TSB150071

Intake Manifold Pressure/Temperature Sensor Water Intrusion Resulting in Fault Code 122, 123, 124, 125, or 2973

Figure 1, Water Accumulation On The Air Intake Manifold.

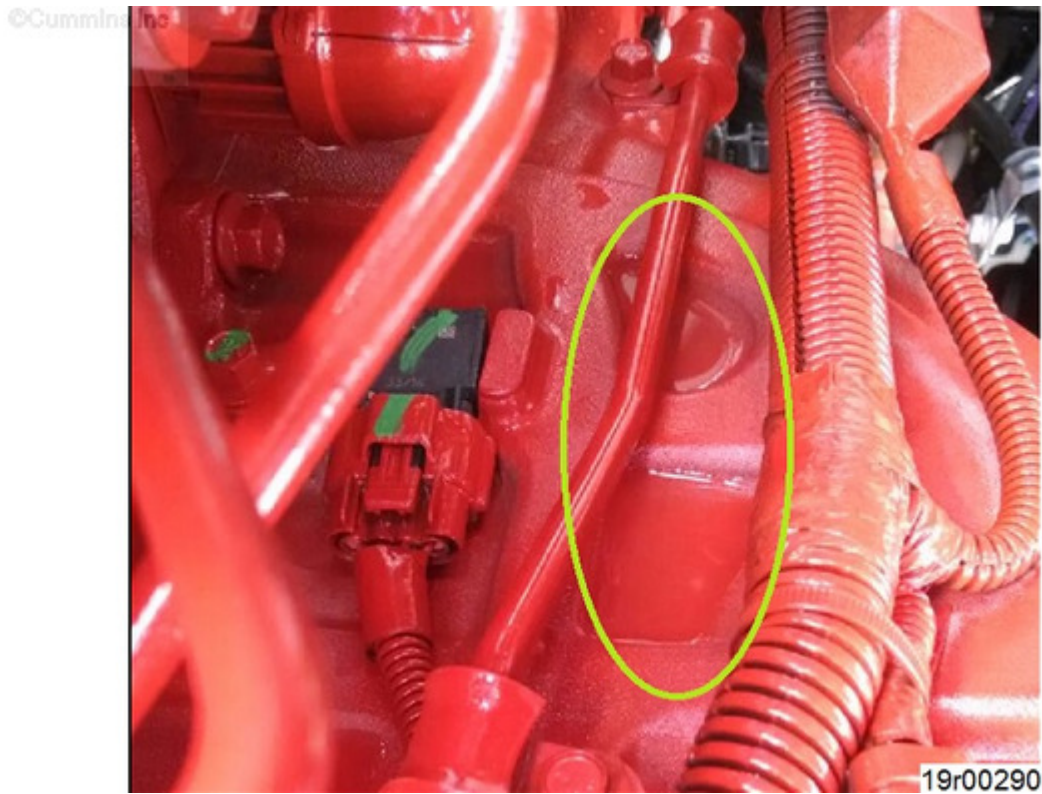
The capacitor in the new intake manifold pressure/temperature sensor is **not** completely covered in protective silicone gel, leaving the capacitor exposed.

Moisture intrusion from water spray and water/ice accumulation on the air intake manifold can cause corrosion and incorrect sensor readings.

Fault Code(s) 2973, 122, 123, 124, or 125 can be set as a result.

If issue has been verified and intake manifold pressure/temperature sensor serial number range status is **Not** OK per Table 1, replace with part number 2897334, which has a serial number status that is OK per Table 1.
